*Rogerson & Birch Surveyors – Proposed Subdivision Plan,  
Overlay Plan and Falls Site Building Plan*

*Agricultural Report and Peer review*

**PLANNING APPEAL – 255 MARCHWIEL ROAD, BREAM CREEK  
SECRET SOUNDS GROUP PTY LTD V SORELL COUNCIL - P/2025/13**

# Marchwiel Road Dam Feasibility Report

**Proposed Subdivision**  
**Date:** 13-07-2022  
**Reference:** QUINB01 14425-03  
**Scale:** 1:10,000 (A3)  
**Municipality:** SORELL

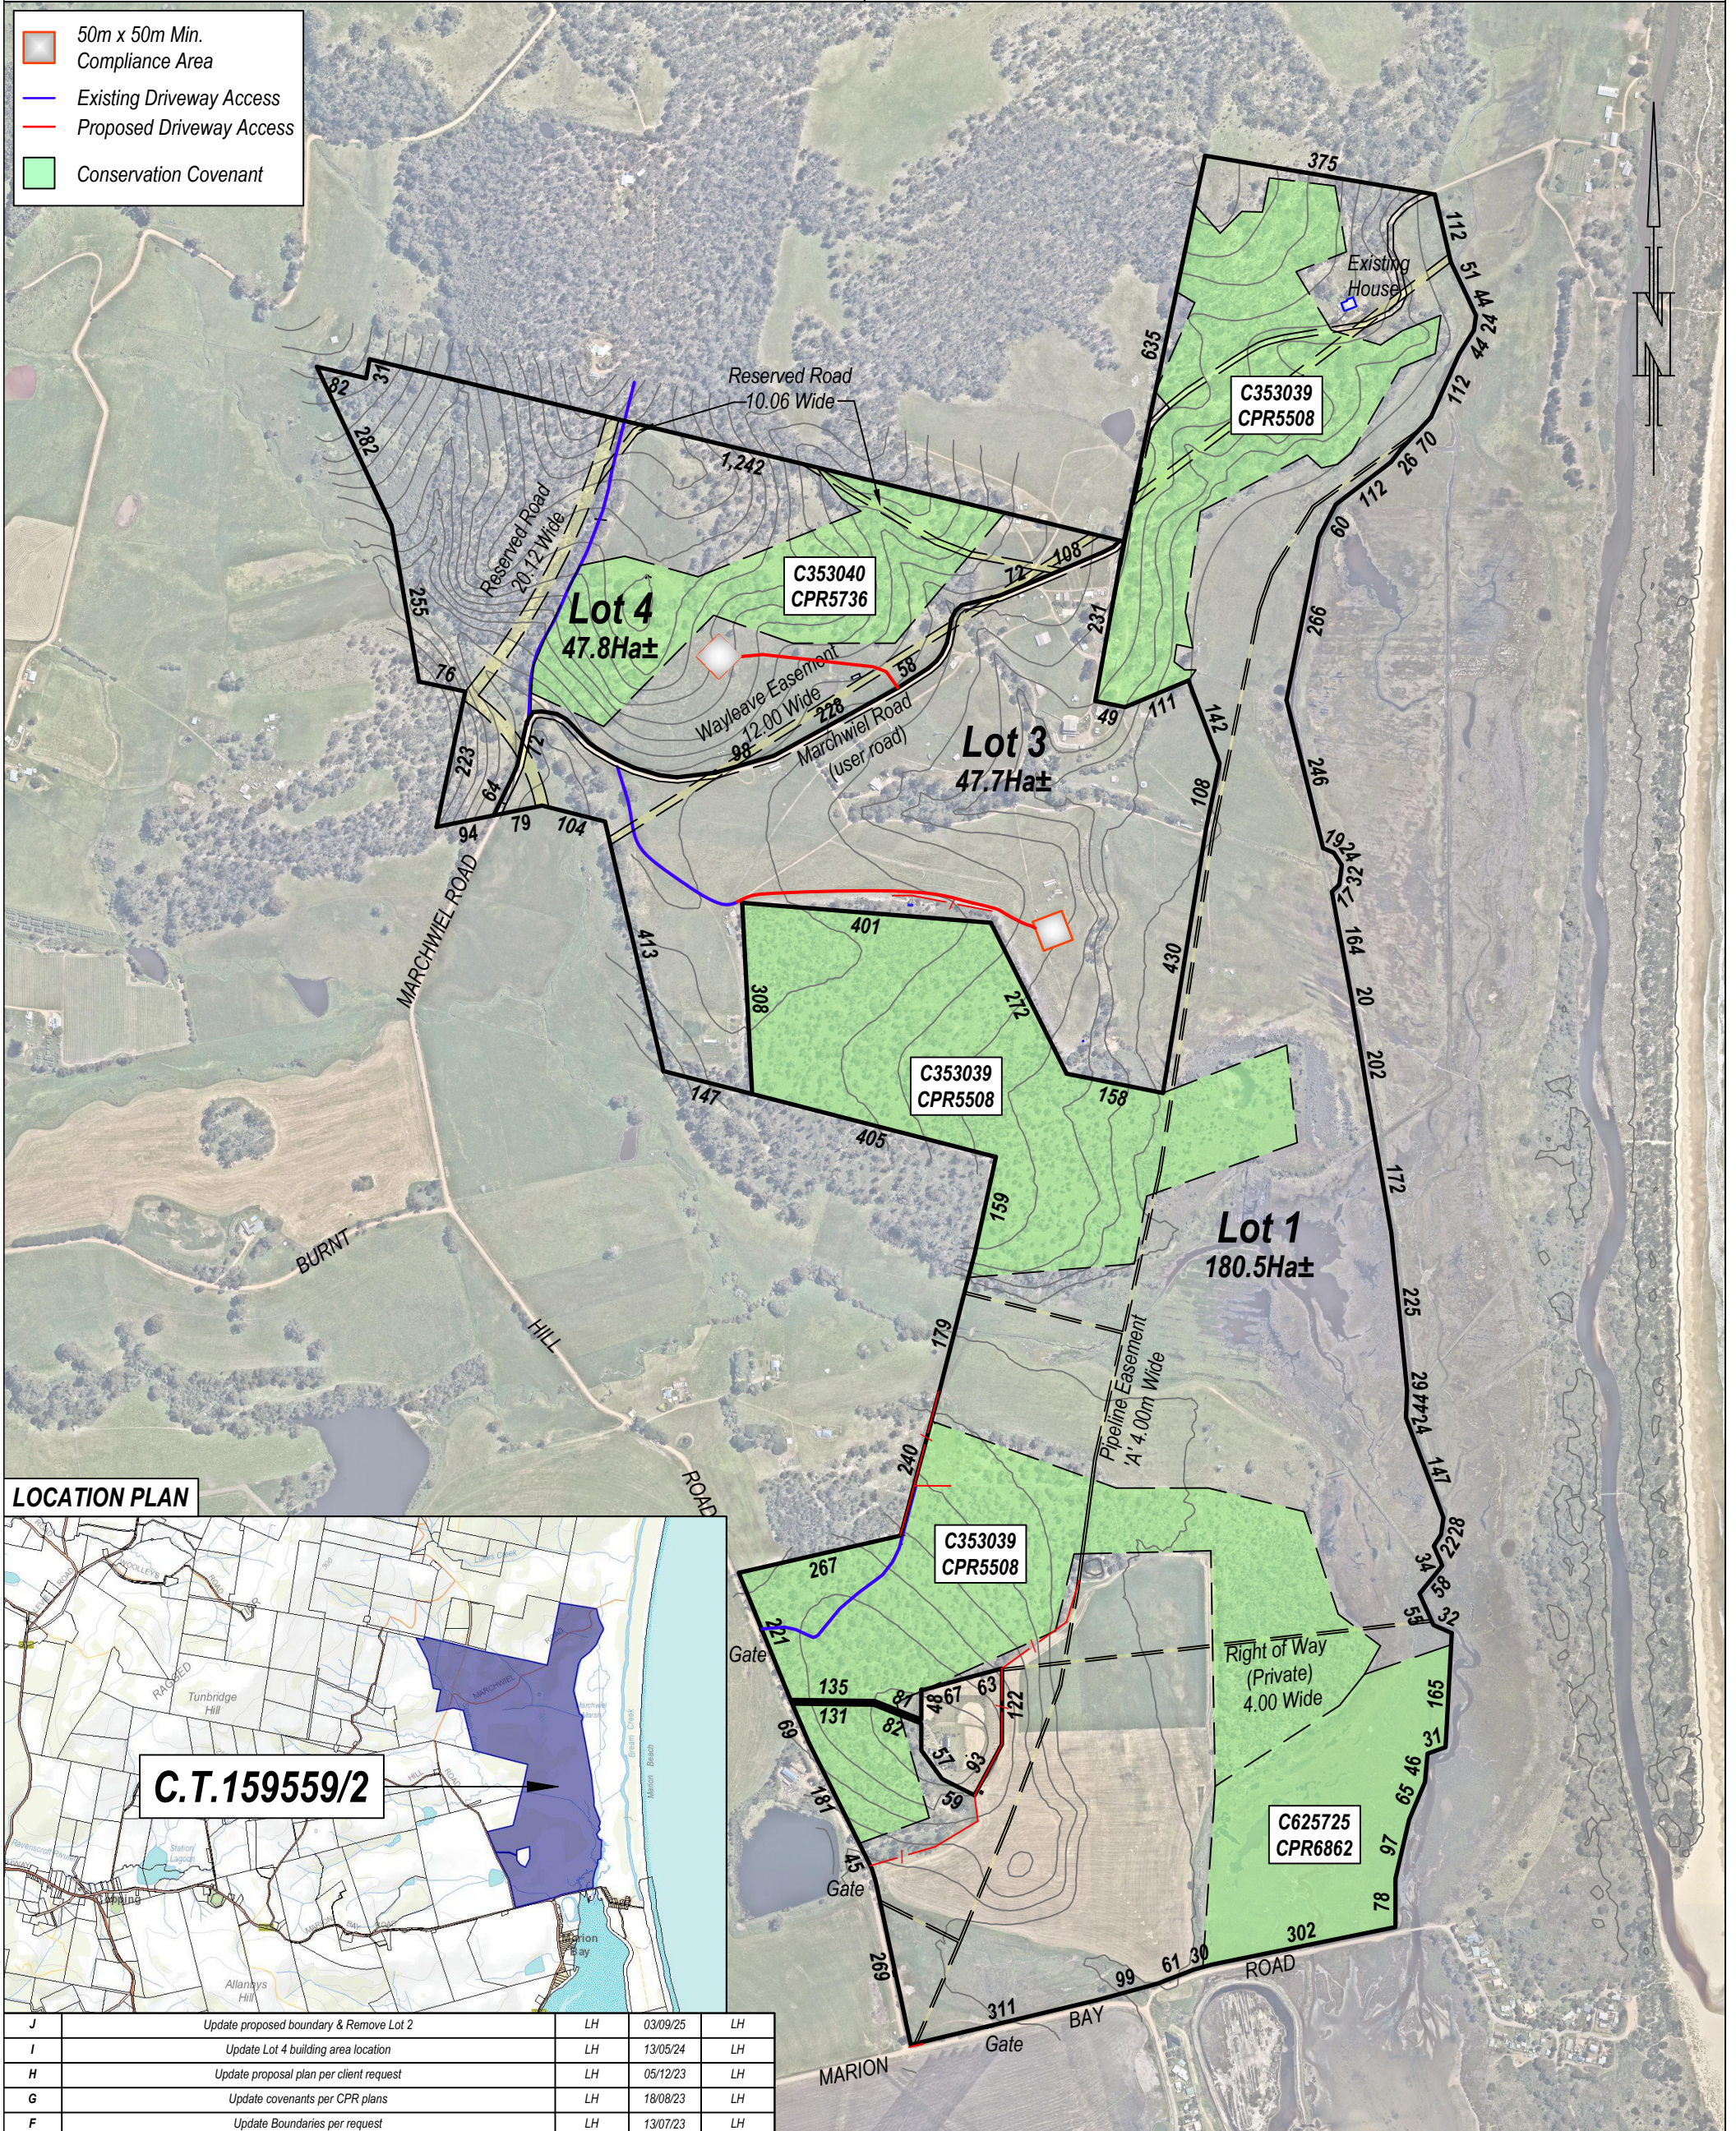
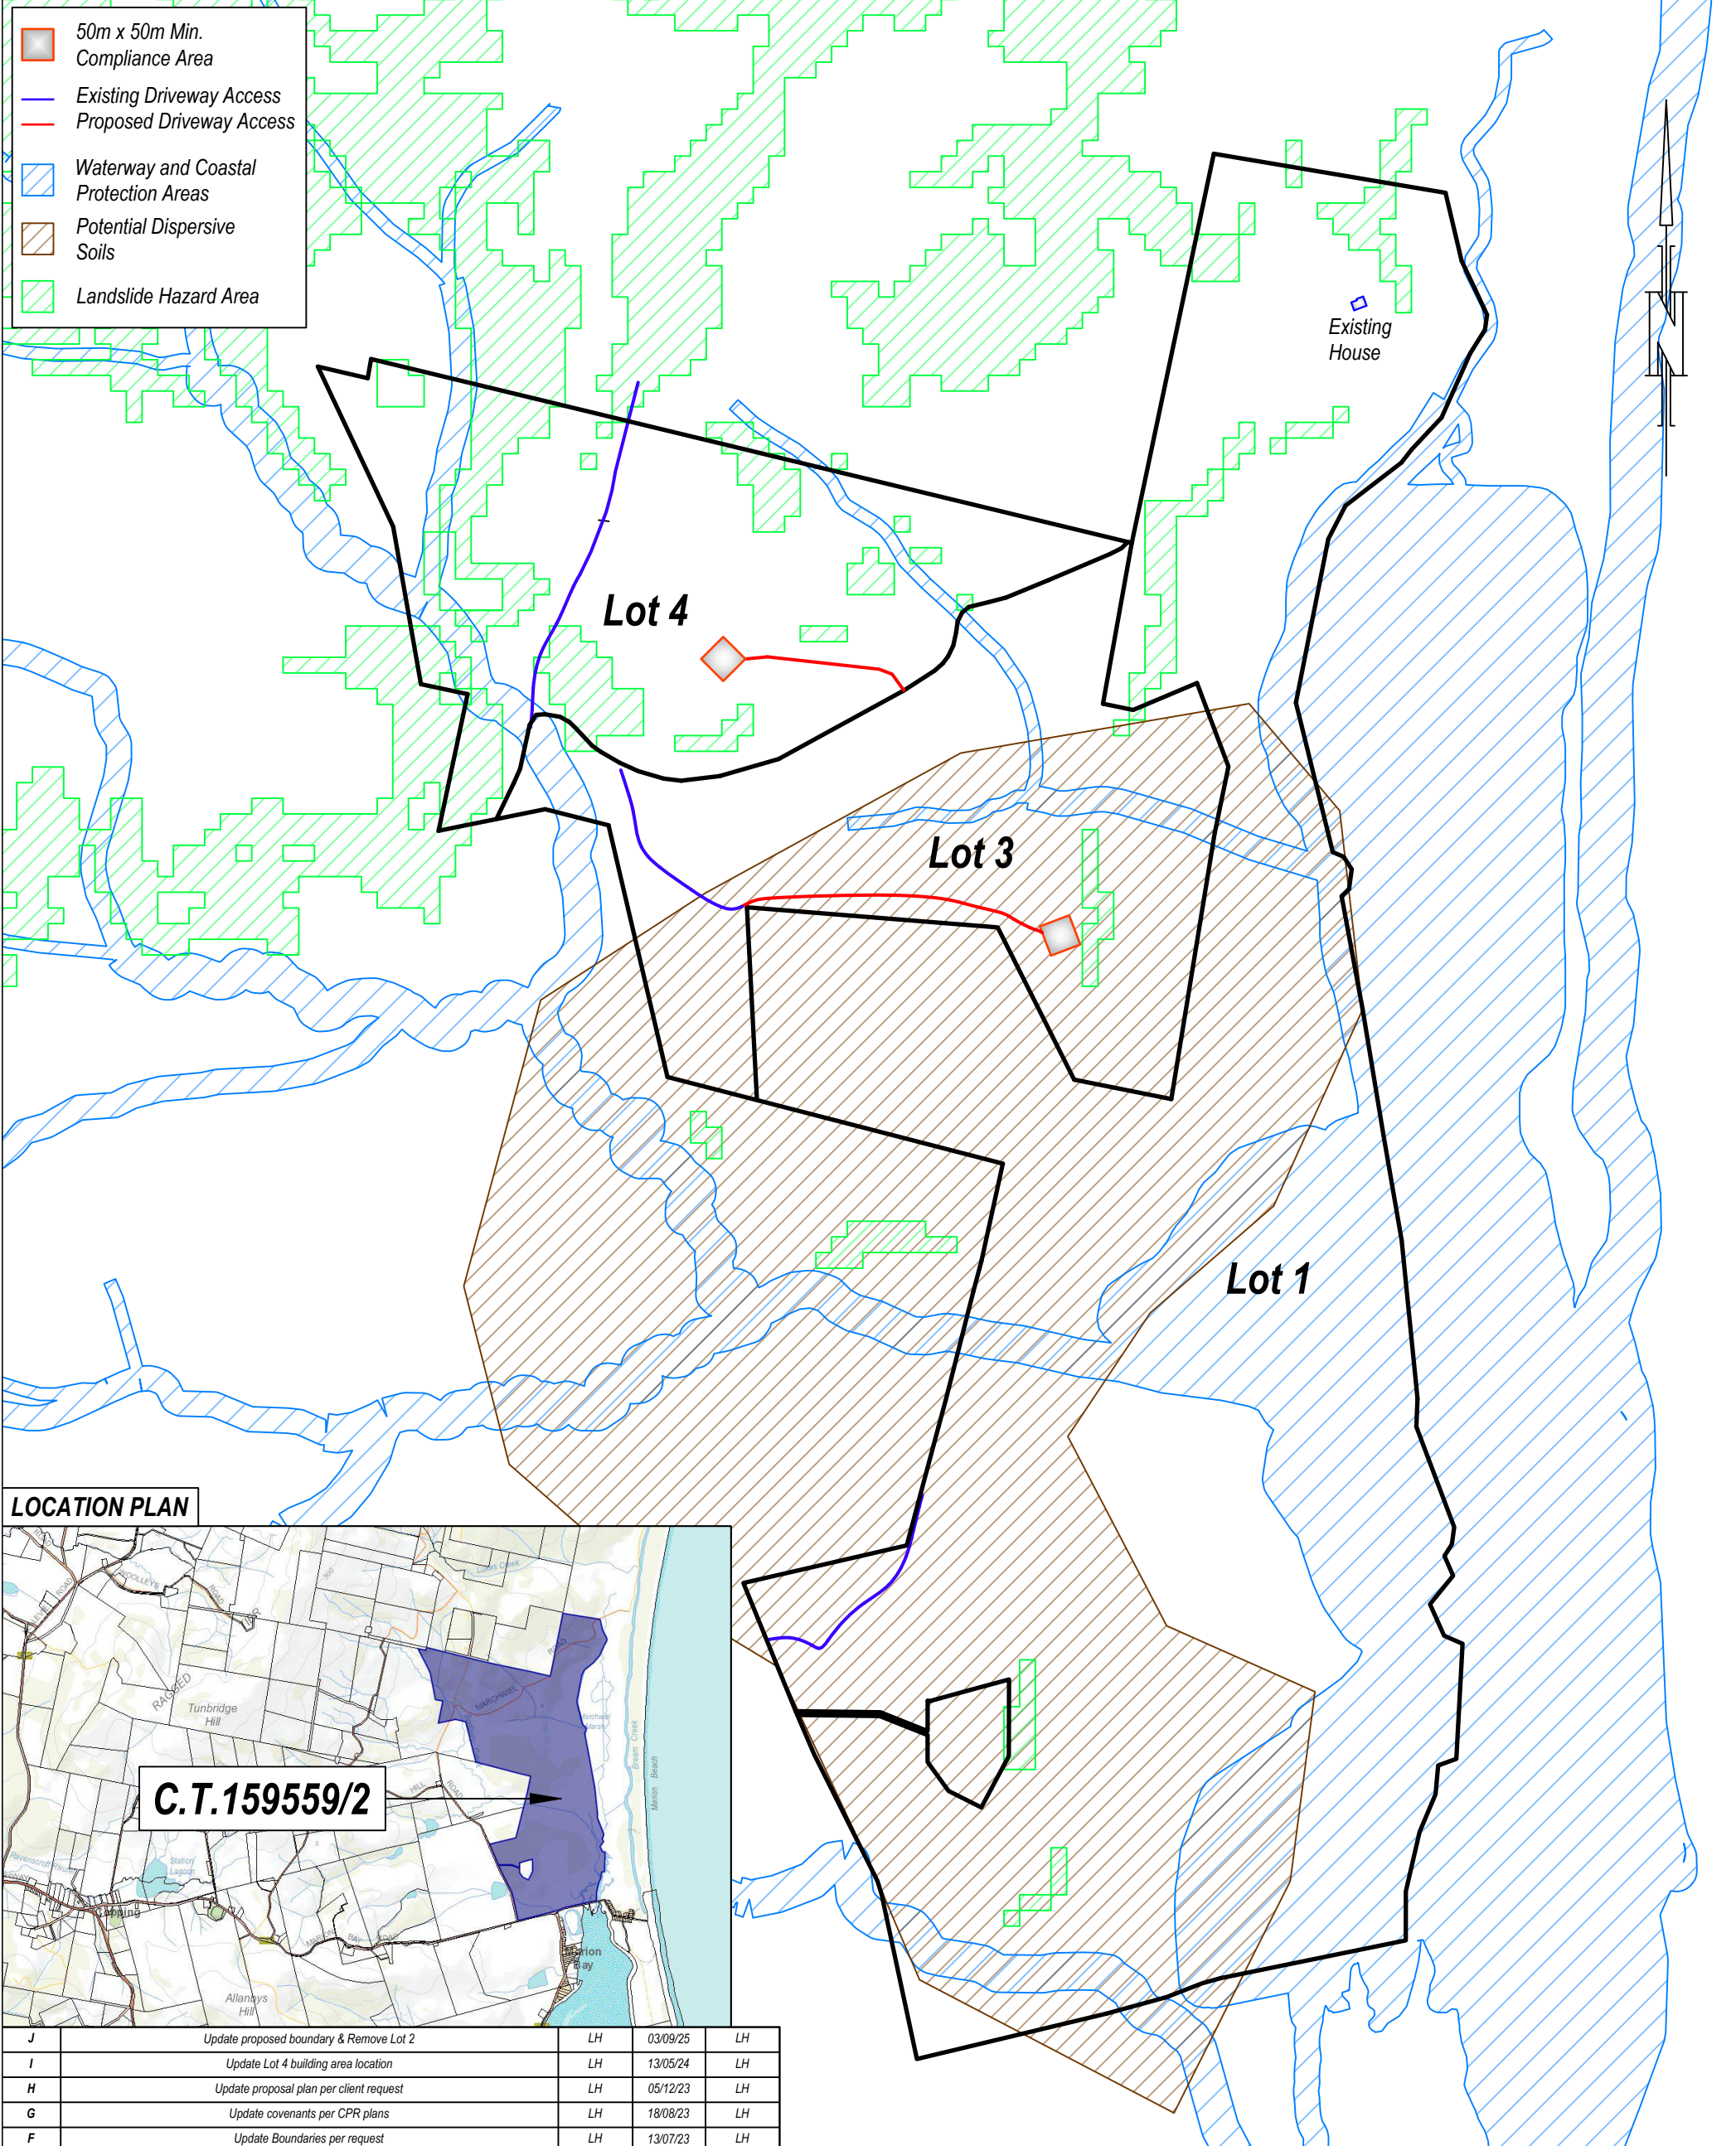
**Attached** to this correspondence is a revised plan of subdivision that shows Lots 1 and 2 to be combined as a single lot, now numbered Lot 1. The boundary between what is now Lot 1 and Lot 3 has been adjusted to increase the area of flat pasture to be accommodated within Lot 1 while still maintaining sufficient land within Lot 3. As discussed, my client's preferred future for Lot 3 is to retain this lot and develop a vineyard/cellar door site.

Lot 3 is reduced in area from 53.2ha to 47.7ha. The selected boundary now follows the easement over the property, with the easement to be located wholly within the area of Lot 1.
